CNL-17-074

Clinch River Nuclear Site
NRC Docket No. 52-047

Subject: Submittal of Supplemental Information Related to the Hydrologic Engineering in Support of the Clinch River Nuclear Site Early Site Permit Application - Groundwater

Supplemental Information Regarding Site Safety Analysis Report Section 2.4,
"Hydrologic Engineering"

Figure 2.4.12C-28. Groundwater Heads—Fill Granular Backfill Hydraulic Conductivity of 10^{-3} cm/s in Profile A Model: a) Deep Foundation Embedment and b) Shallow Foundation Embedment

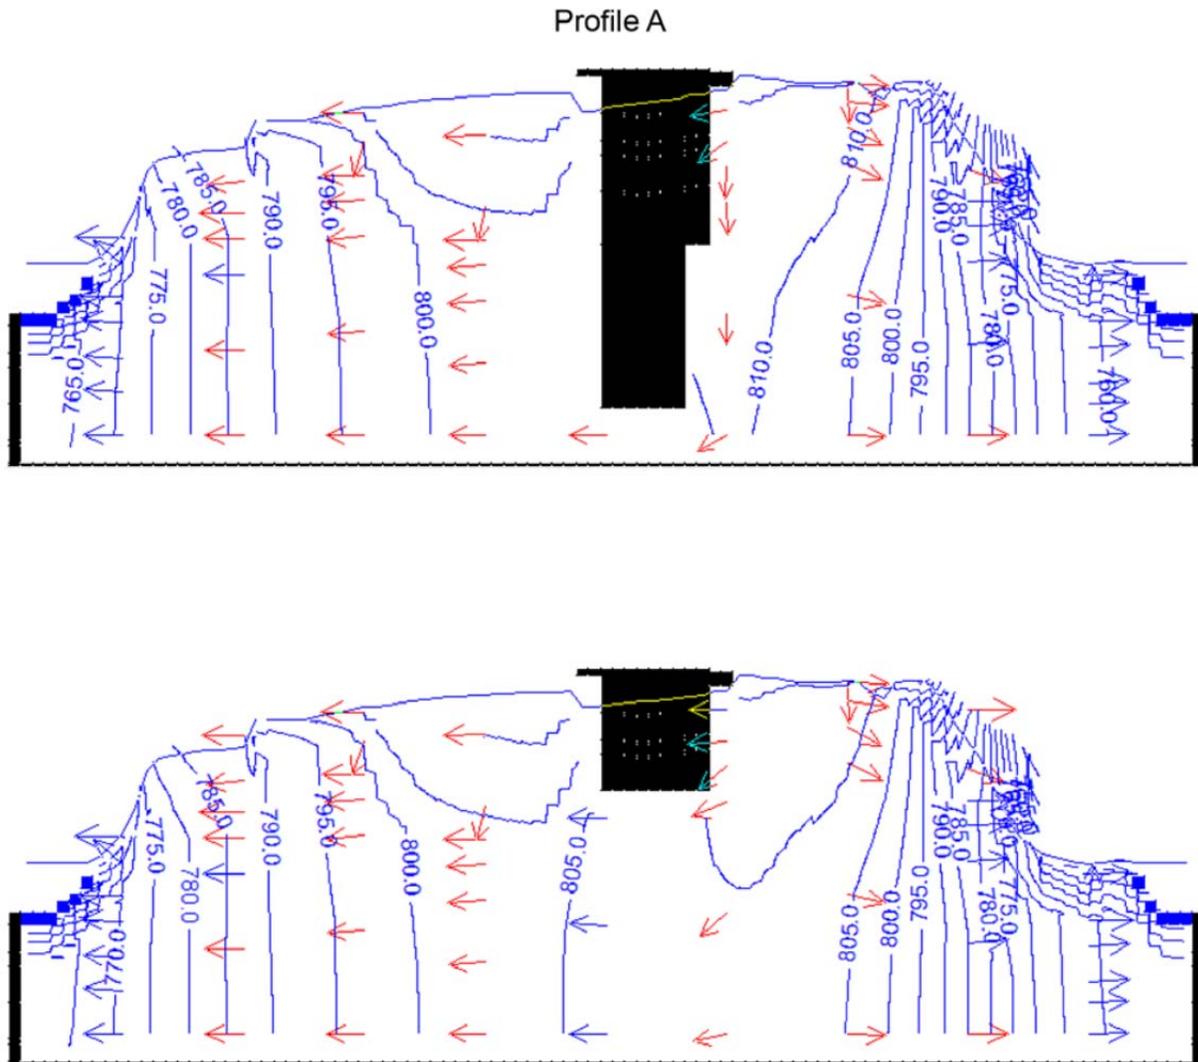
SSAR Figure 2.4.12C-28 is being revised as indicated (no revisions to the image have been made). Strikethroughs indicate text to be deleted. Underlines indicate text to be added.

Figure 2.4.12C-29. Groundwater Heads—Fill Granular Backfill Hydraulic Conductivity of 10^{-1} cm/s in Profile A Model: a) Deep Foundation Embedment and b) Shallow Foundation Embedment

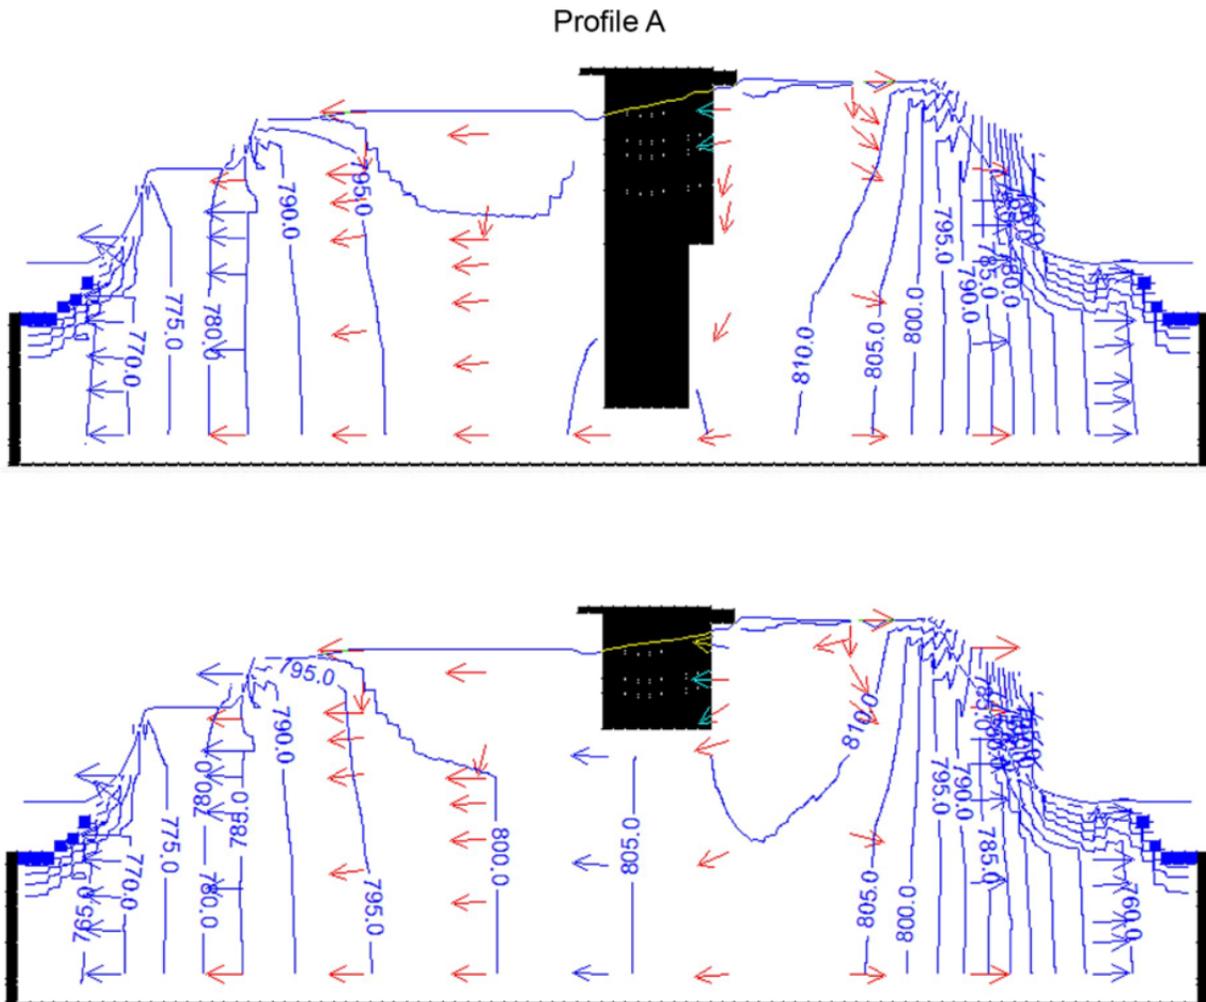
SSAR Figure 2.4.12C-29 is being revised as indicated (no revisions to the image have been made). Strikethroughs indicate text to be deleted. Underlines indicate text to be added.

Figure 2.4.12C-30. Groundwater Heads—Fill Granular Backfill Hydraulic Conductivity of 10^{-2} cm/s in Profile C Model: a) Deep Foundation Embedment and b) Shallow Foundation Embedment

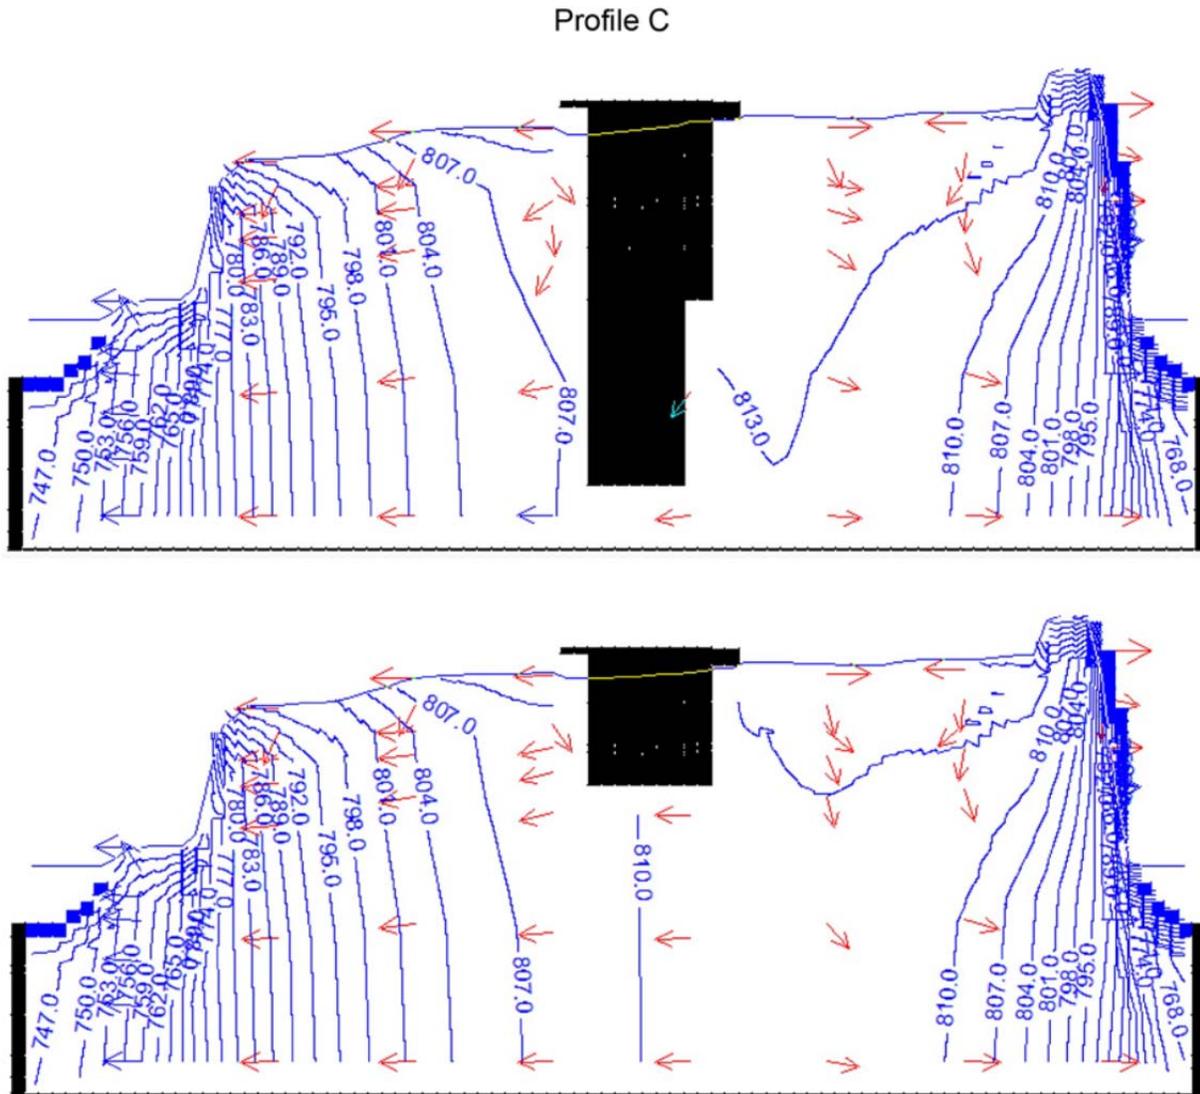
SSAR Figure 2.4.12C-30 is being revised as indicated (no revisions to the image have been made). Strikethroughs indicate text to be deleted. Underlines indicate text to be added.

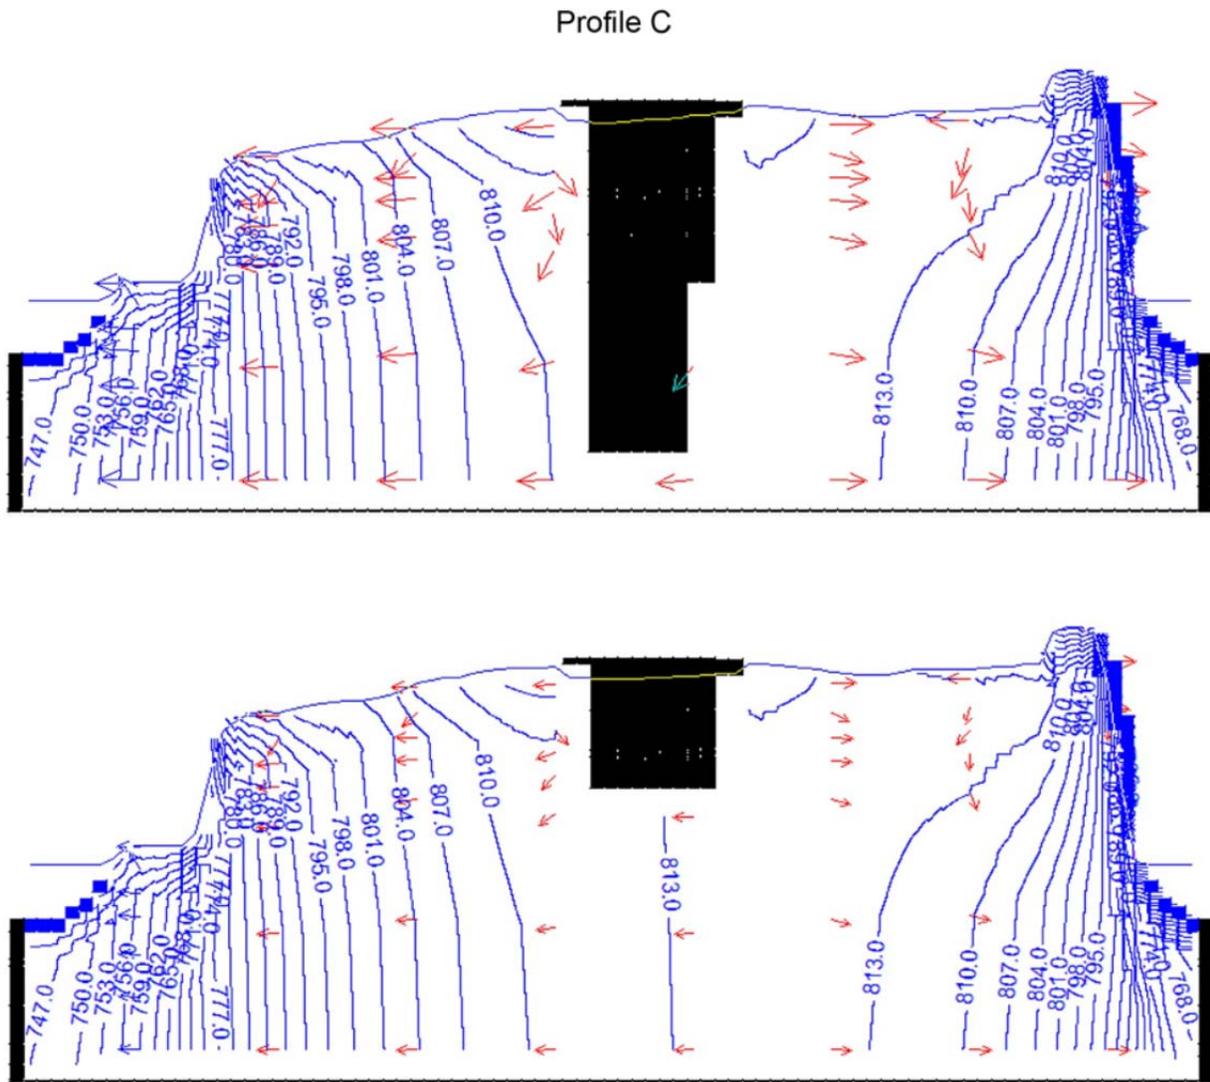
SSAR Figure 2.4.12C-31 is being revised as indicated (no revisions to the image have been made). Strikethroughs indicate text to be deleted. Underlines indicate text to be added.
